September 7th, 2018

Subject: ST3 WSTBE Level 2 preliminary recommendations

ST3 Level 2 Station, Water Crossings,
& Alignment Recommendations

Alaska Junction Station

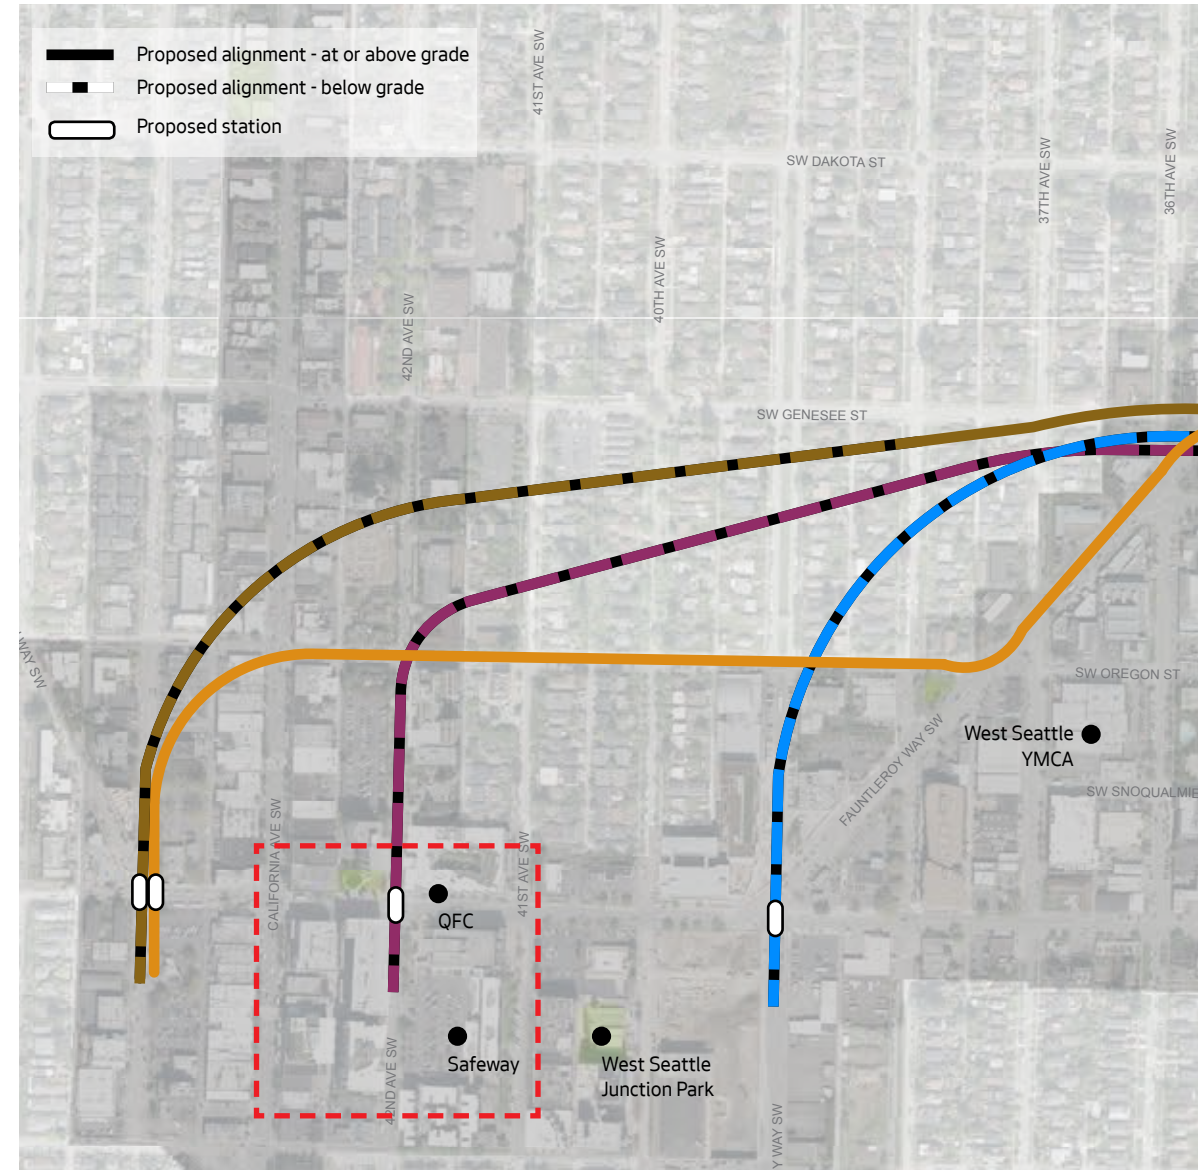
1. 42nd Ave SW & SW Alaska St, below grade
2. 42nd Ave SW & SW Alaska St, above grade

- Avoids impacts to California Ave SW
- Aligns with greater existing and planned residential density east of California
- Proximity to California supports N/S bus corridor
- Better ADA accessibility to California than the Fauntleroy location due to relatively small grade change
- More pedestrian friendly than Fauntleroy
- Reduces potential impacts on existing development and character along California
- Below grade station is preferred because
 - Less impact to the surrounding neighborhood central commercial area
 - Capitalizes on terrain
 - Less disruptive to traffic
 - Need to acquire less property
 - Less disruptive to community in areas where the alignment turns
- If station is located above grade, 42nd Ave SW is the best location given the scale of existing development
- If 35th Ave SW is best corridor for future light rail expansion, station near Fauntleroy might be better option

- Orient station N/S for future system expansion
- Explore potential joint development options of Jefferson Square block

Alaska to Avalon Line

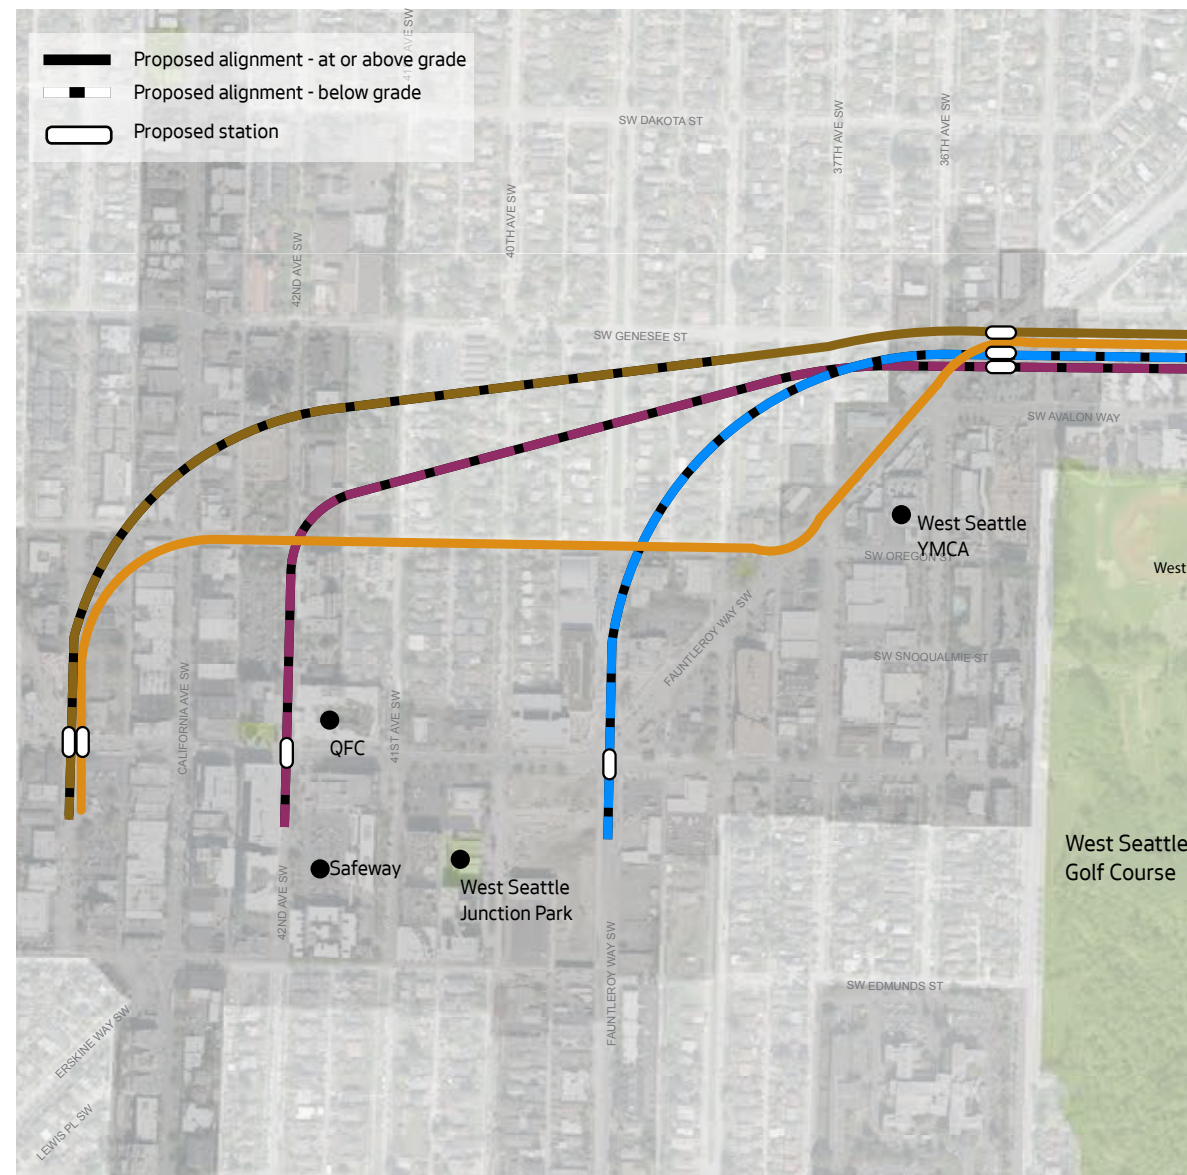
1. Below grade ■
2. Above grade along Fautleroy and Alaska St ■

- Below grade alignment will significantly reduce negative impacts on community experiencing rapid growth
- A below grade alignment eliminates the challenges of significant variation in grades in this segment that will likely result in unusually high guideway and station elevations

- Provide information and analysis of visual impacts and cost of the above grade alternative

Avalon Station

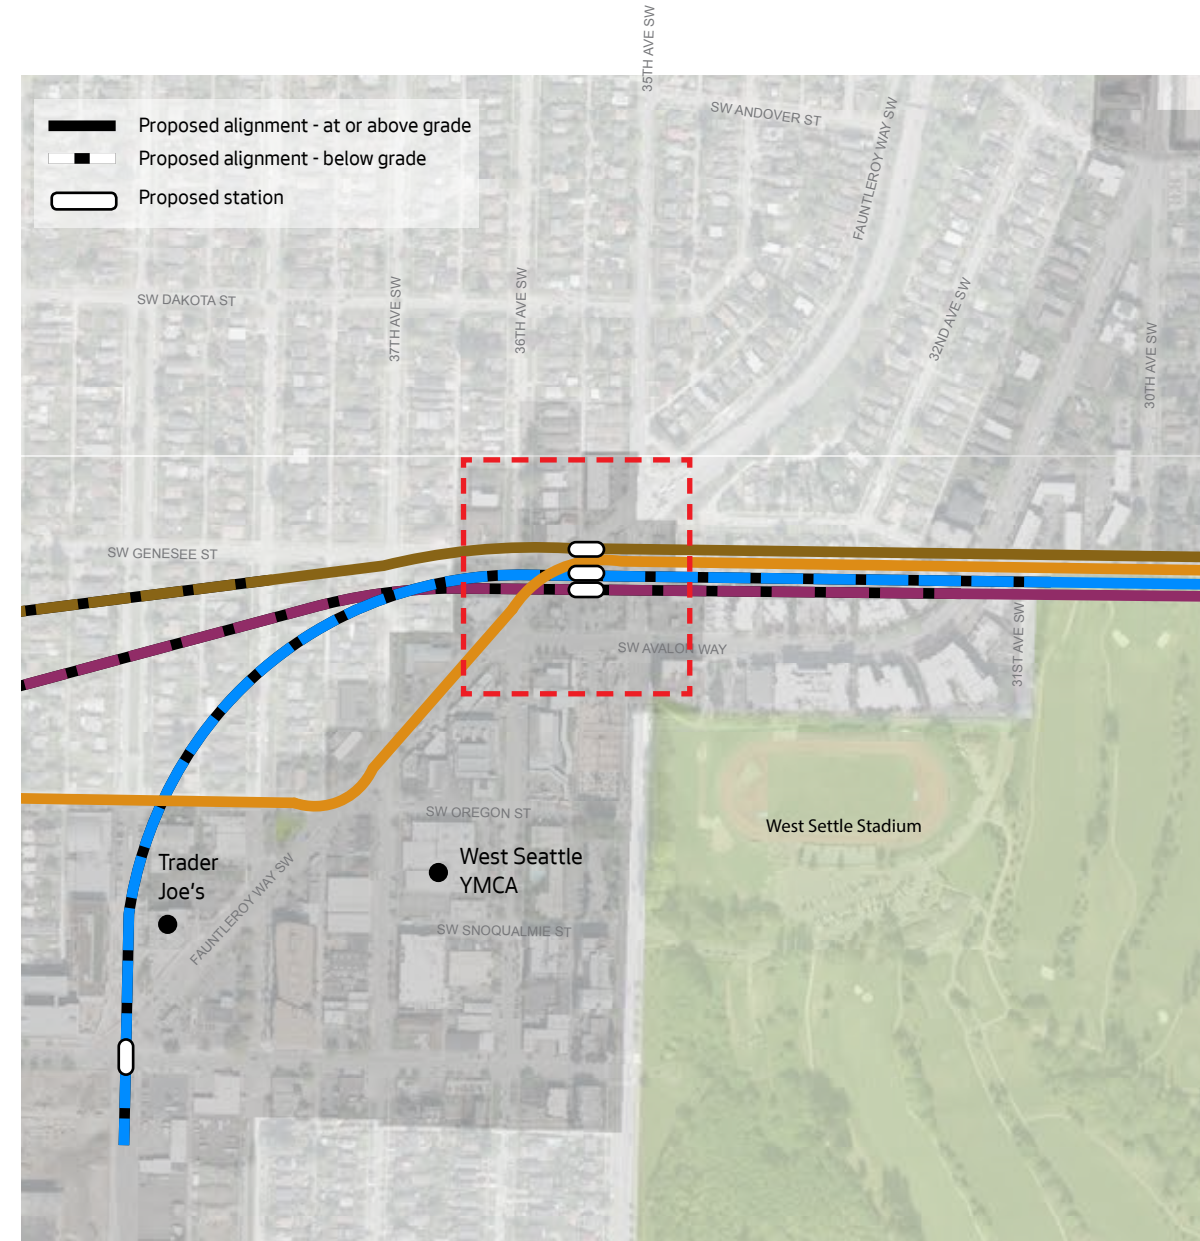
Study: Fauntleroy & SW Genesee

- A station at Avalon supports universal access due to the significant grade changes and distance between West Seattle Junction and Delridge
- Station west of Fauntleroy aligns with greater zone density
- Station spanning street improves pedestrian connectivity to neighborhoods, assuming multiple station entrances are provided

- Provide an Avalon station. However, if necessary for cost savings, defer station construction and design for future expansion.
- Don't locate station north of Avalon because of lower zone density
- Consider the Taco Time site as a station location due to site size, location and underdeveloped site
- Improve pedestrian crossings at Fauntleroy
- Provide information and analysis of populations that will use station
- City should examine the idea of converting the golf course into a more intensely usable recreation use that will generate greater ridership

Delridge Station

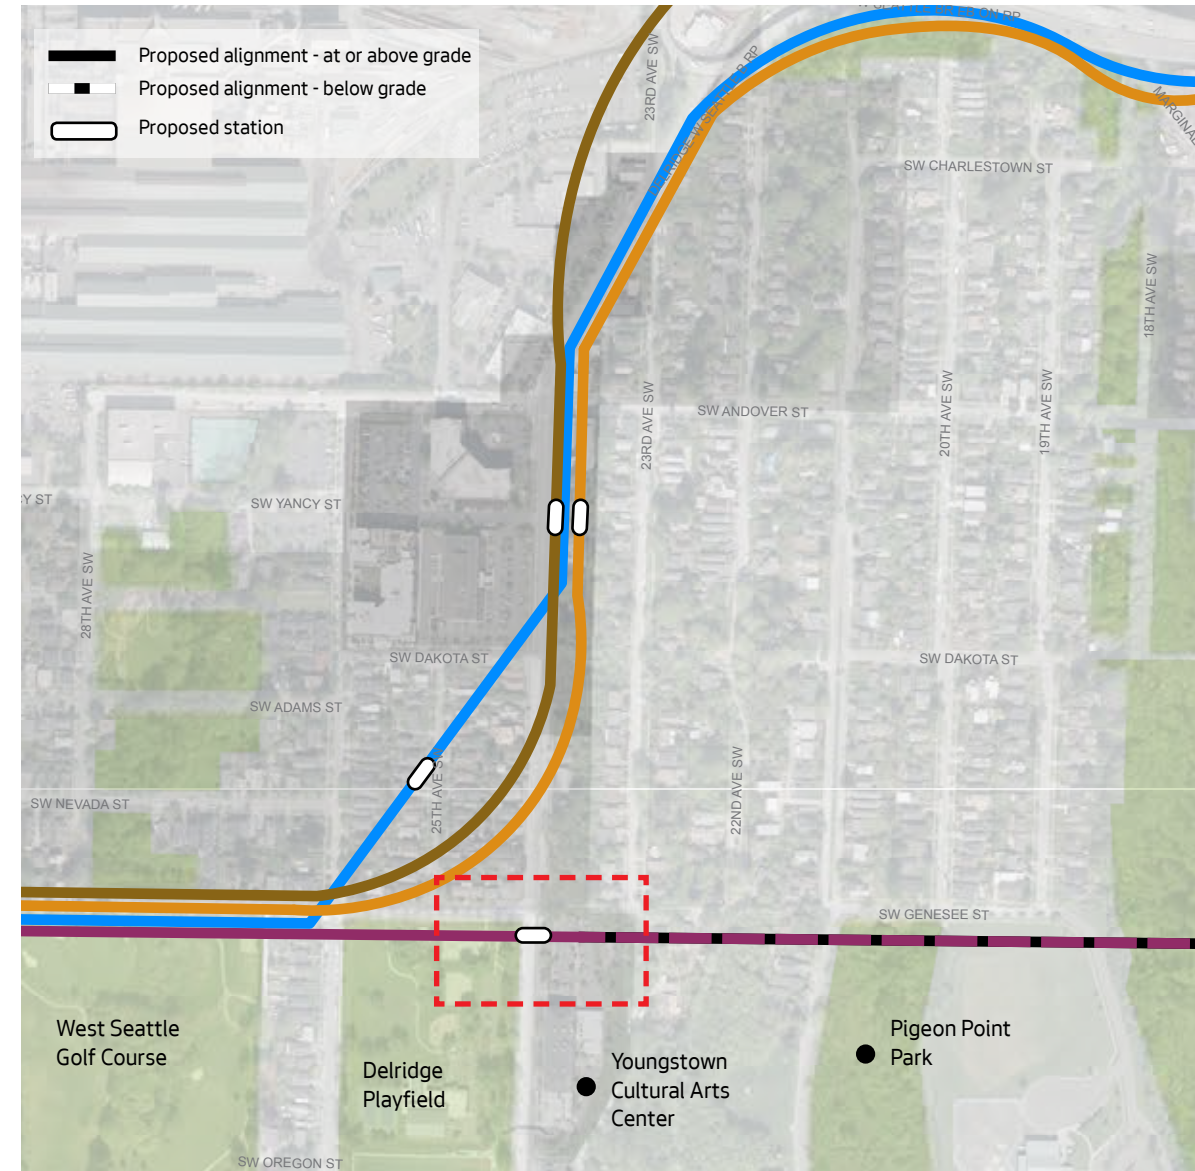
Study: Genesee and Delridge, above or at grade

- Serves the larger community along Delridge Way corridor:
 - Better connection to South Seattle College
 - Better service for underserved communities
 - Provides a transfer location for communities located south of station area
 - Better serves Delridge hub including community center, skate park, and Youngstown Cultural Arts Center
- Has lower station and guideway heights than alternatives to the north
- Supports bike mobility and connections to greenway and surrounding community
- Better connectivity to existing and future bus lines including Rapid Ride

- Study TOD potential north of Genesee and west of Delridge Way SW, including affordable housing opportunities. Creating permanent affordable housing can reduce or stabilize impacts that the station may have on current market-rate affordable housing in this area
- Due to potential significant economic and social impacts from the station and the guideway on property values, closely consider both construction staging impacts and long term development potential when evaluating station options at this location.

Avalon to SODO Line (part 1)

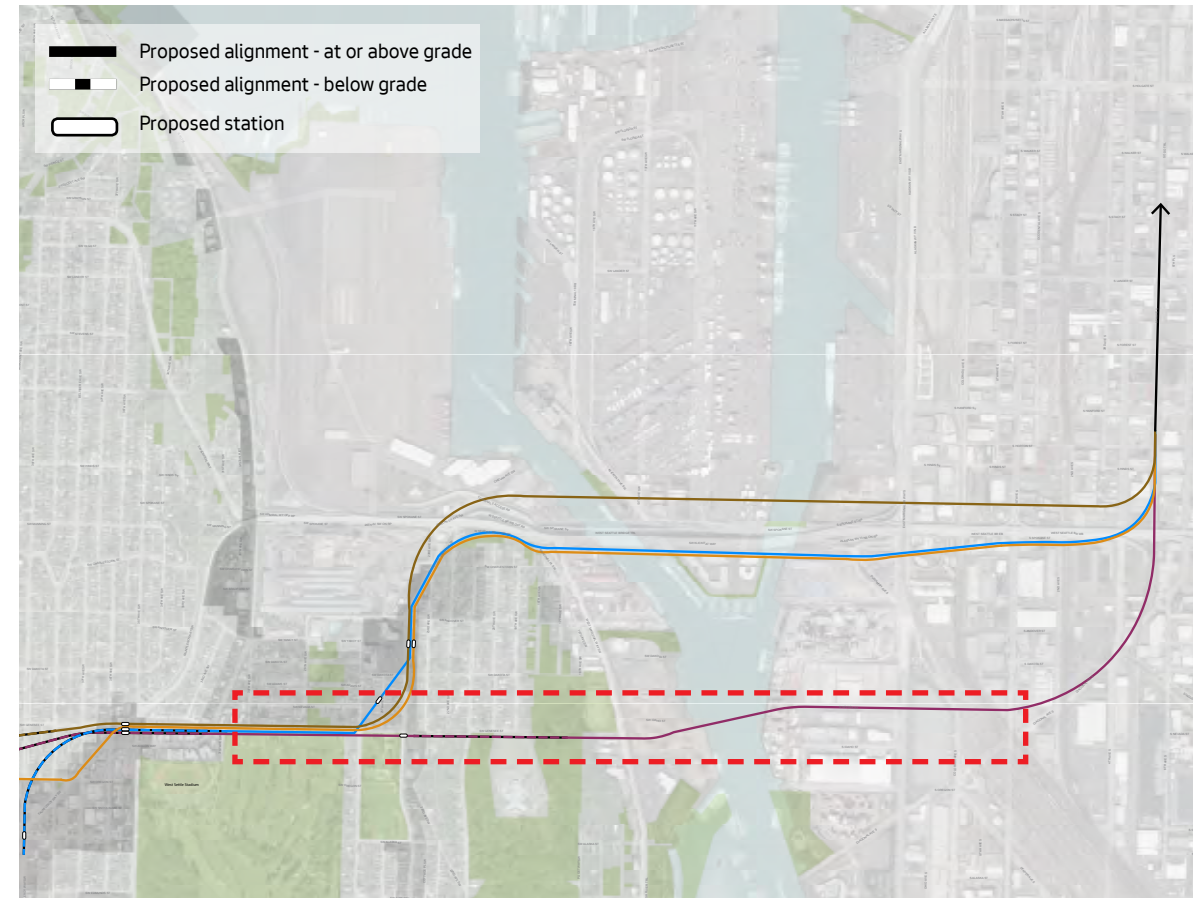
1. "Pigeon Ridge" along Genesee or south of it, elevated except for tunnels under Pigeon Ridge and at grade in parts of SODO ■
2. Northern most Duwamish crossing in tunnel or elevated ■

- Produces less overwater coverage over Duwamish River
- Simplifies alignment between SODO and Alaska Junction (reduces number of curves/turns)
- Has less impact on the Port of Seattle operations at Harbor Island

- Reduce impacts to environmentally sensitive areas and Pigeon Point residential areas
- Avoids technical difficulties of locating guideway in narrow area between West Seattle Bridge and Pigeon Point hillside

- Allows for lower guideways in the neighborhood and lower Delridge station
- Reduces height of elevated sections across Longfellow Creek
- Works best with terrain/grade change

- Avoids extremely high guideways along north end of Delridge Park
- Allows for potential infill light rail station east of E Marginal Way
- A below grade alignment eliminates the challenges of significant variation in grades in this segment that will likely result in unusually high guideway and station elevations

- Avoids Pigeon Point neighborhood environmental impacts
- If in a tunnel has fewer impacts than other alternatives along existing bridge

Avalon to SODO Line (part 2)

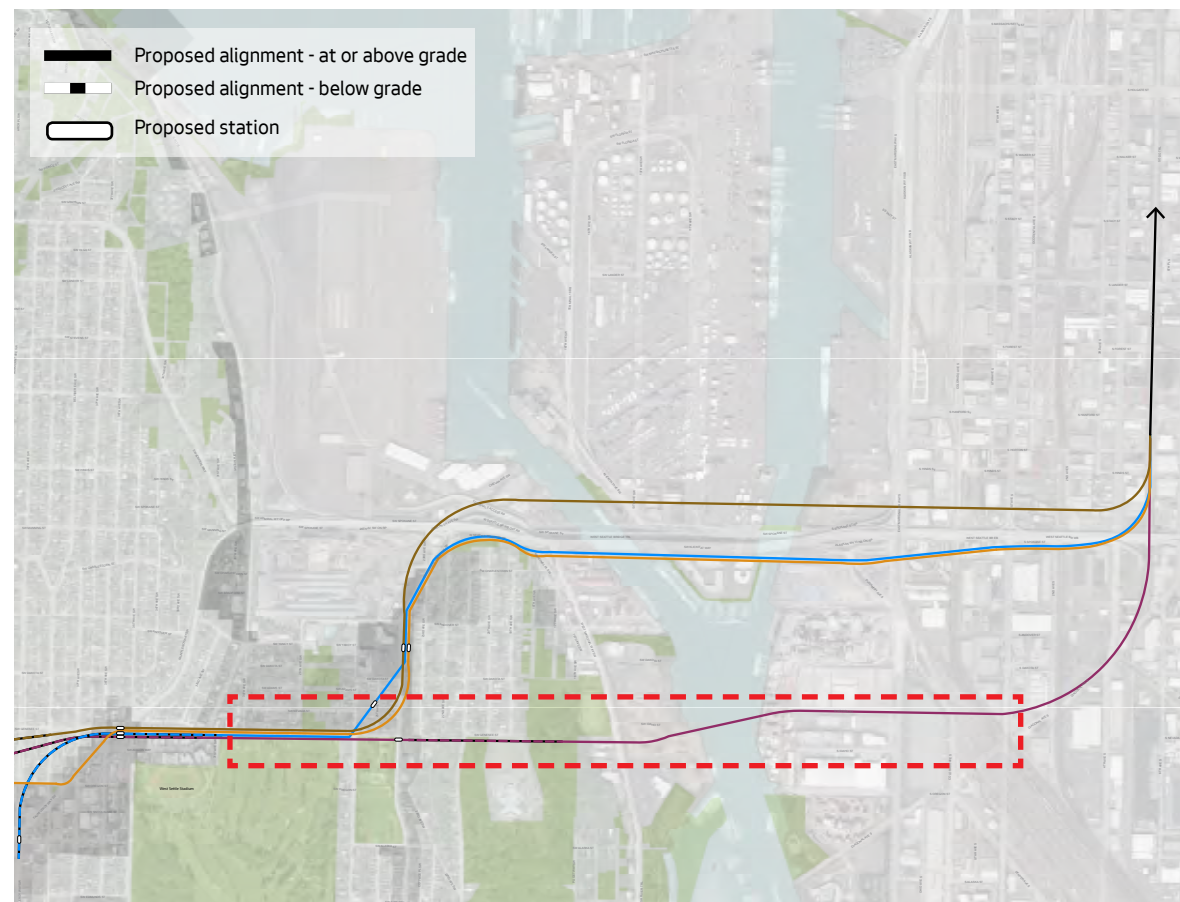
- Study possible solutions for routing past the Seattle City Light substation
- A new bridge in any location should be complimentary to its surroundings and sensitive to its natural, cultural, and built context

Study cost savings from eliminating either Pigeon Ridge or Alaska Junction tunnel. Challenges with this option include

- Further impacted communities resulting from insufficient infrastructure investments
- Physical impacts to densest residential neighborhoods in West Seattle

SODO to Chinatown ID Line

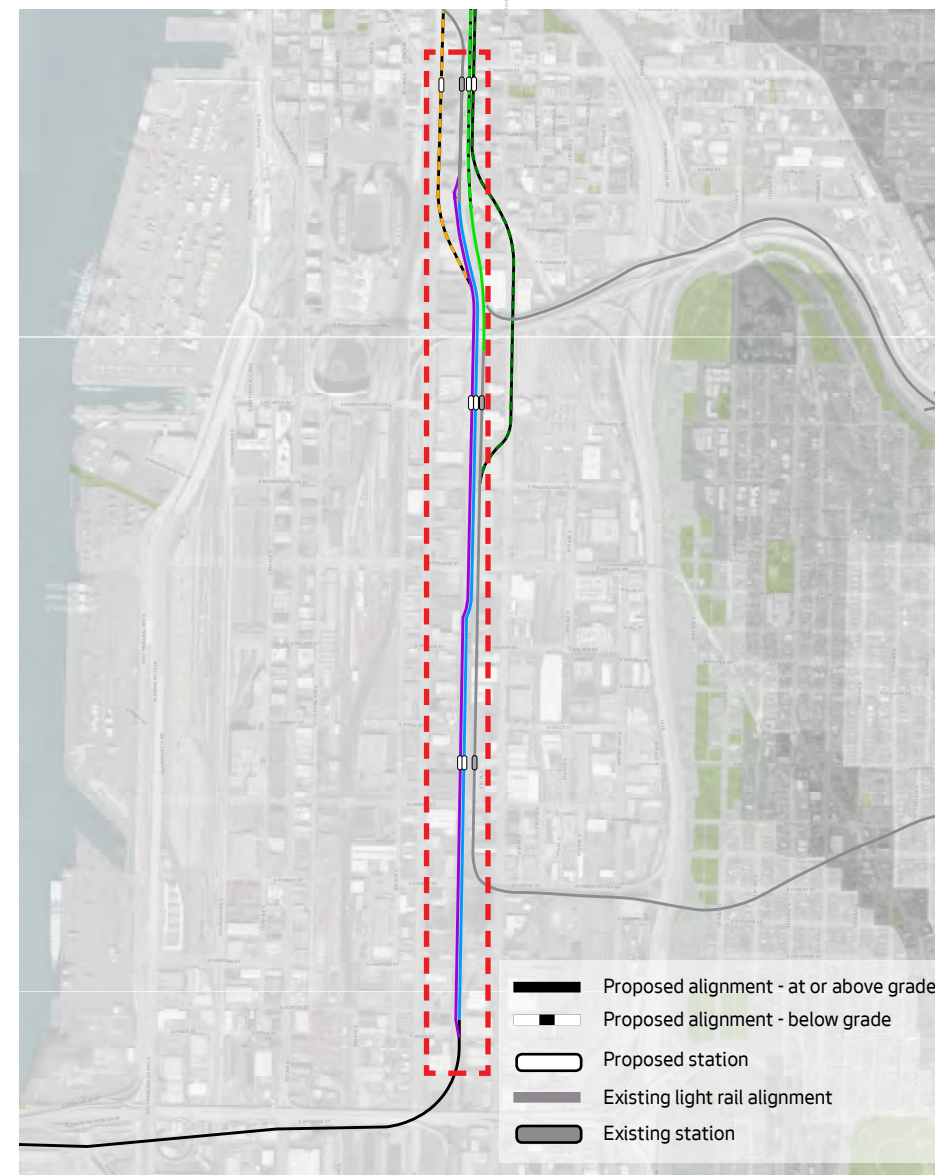
1. E-3 Corridor, at grade at south and below grade at north ■ ■ ■ ■
2. First Ave or another western alignment

- Buses in the existing E-3 corridor provide transit to S. King and Pierce County, where more affordable housing to options are located. Explore and use data on these jobs and housing connections to support preferred option.

- Continue to study both E-3 and First Ave in Level 3 analysis. The location alignment will significantly affect transfer opportunities for travel to other rail segments.

- Transfer strategies between transit modes (rail, bus, etc.) should be provided for all station and alignment options under review.
- Place the alignment in a location that offers best connections to the Chinatown ID station.

- If the E-3 corridor is used, retain the bike trail in this right-of-way. If not, relocate bike trail after evaluating best alternative options.
- Study at grade pedestrian and bike improvements versus overpasses crossing rail lines at Lander and Holgate. Walking or riding over the tracks is more cumbersome and less attractive. Weigh this with data on anticipated wait times at grade.

- Provide a transfer strategy for the various light rail and high volume bus lines that converge here - Eastside, SeaTac Airport, West Seattle, Tacoma. The transfer strategy will significantly influence station configurations. Knowing the strategy is crucial to evaluating the station options.

- Given the extended interim period between the opening of the West Seattle and Ballard extensions, consider terminating the West Seattle extension at Chinatown/ID rather than SODO. This will allow for multiple transfer opportunities between the existing light rail line and other regional transit modes.
